Re: CPV Sentinel Energy Project: Docket No. 07-AFC-3

# **Responses to Groundwater Workshop Additional July 3, 2008 Data Requests**

## **Application for Certification (07-AFC-3) for CPV Sentinel Energy Project Riverside County, California**

### RESPONSES TO GROUNDWATER WORKSHOP DATA REQUESTS (SET 2, JULY 3, 2008)

MISSION CREEK SUBBASIN			
Project: No.: 28067168.40000	Date: July 2008	Project: CPV Sentinel Energy Project	Figure: 1

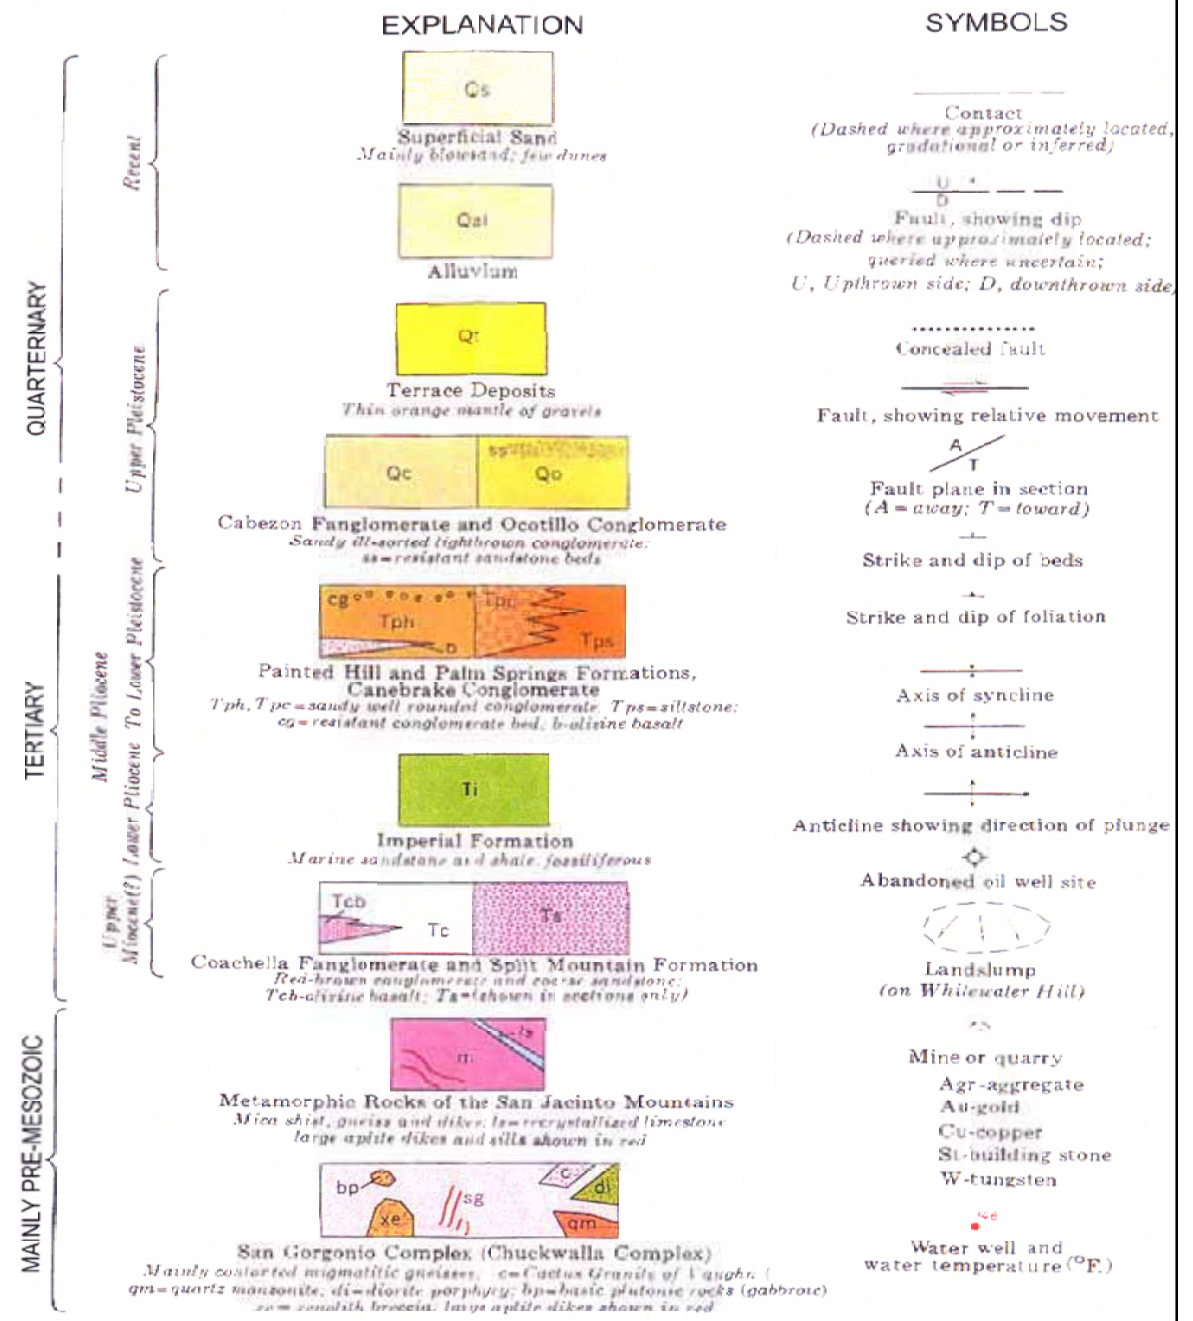
4. ***Figure 1 shows the locations of the wells reported in Table 1; Figure 2 shows well locations relative to Tyley's T distribution map (the T distribution simulated by the model); and Figure 3 shows well locations, posts some of the T values from Table 1, and provides an interpretive distribution of T in the basin based on some of the T values from Table 1. Why were not all of the values posted and utilized in Figure 3? I noted the disregarded values tend to be the "low" T values relative to the Tyley T distribution (DHSCWD #13, #14, and #16 and MSWD #23). The T value for MSWD #27 is also missing from Figure 3.***

5. ***It appears one of the wells listed in Table 1 is missing from Figure 1 (MSWD#20). It has the lowest T value reported in Table 1 (11,600 gpd/ft) – this well should be posted or an explanation given for why it could not be located or should not be considered.***

URS has included updated versions of Table 1 and Figures 1, 2, and 3. All of the available T values are now posted on Figure 3, including MSWD #27 with a T value of 285,000 gallons per day per foot (gpd/ft). As noted on the figure, not all of the values were used because some of those values were considered questionable in light of more recent data from nearby wells. Most of the wells that were not included had smaller diameters and were shallower, older wells with relatively lower pumping rates. These were near larger-diameter and deeper, newer wells with higher pumping rates. Most of the wells installed before 1970 were 8 to 10 inches in diameter, and before 1969 none of the wells was screened or perforated deeper than 400 feet bgs. Most of the wells installed between 1970 and 1993 had diameters of 14 to 16 inches with boring depths up to 1,200 feet bgs and screen intervals ranging to depths of 1,080 feet bgs. Note that MSWD #27, which has a total depth of 400 bgs with the bottom of the screen interval at 380 feet bgs, is the one exception to this well set. Some of the T values shown on Figure 3 appear to be representative of improved well drilling, design, and development techniques with time.

As noted in the response to Data Request 4, MSWD #20 (reported as DHSCWD #20) is now included in Table 1 and Figures 1, 2, and 3. While the DHSCWD #20 T value is reported in Figure 3, it was treated as erroneous and was not included in the T distribution contouring for reasons given above.
